PRODUCT BULLETIN

SUBJECT: Q90-100 Series Boilers - Hot Surface Igniter Change

Fig. 1

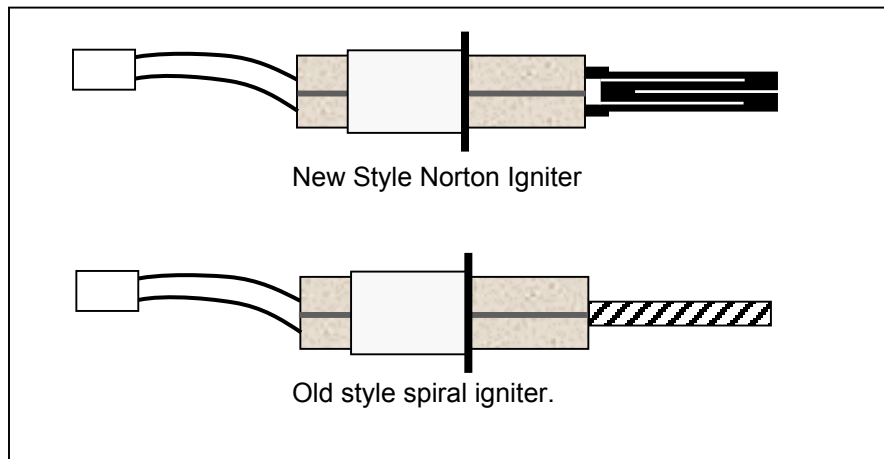
The Q90 50-100 series of boilers are now being manufactured utilizing a Norton brand hot surface igniter. The previously used igniter has been phased out and replaced by the Norton igniter. Both igniters continue to be approved for use with the Q90 50-100 series of boilers and are cross compatible.

The shape (see Fig. 1) of the Norton igniter creates a larger surface area resulting in improved ignition. This is especially helpful for LP gas. The Norton Igniter has also proved to be more robust, increasing igniter life.

The part number for the replacement igniter kit will remain 43800013.
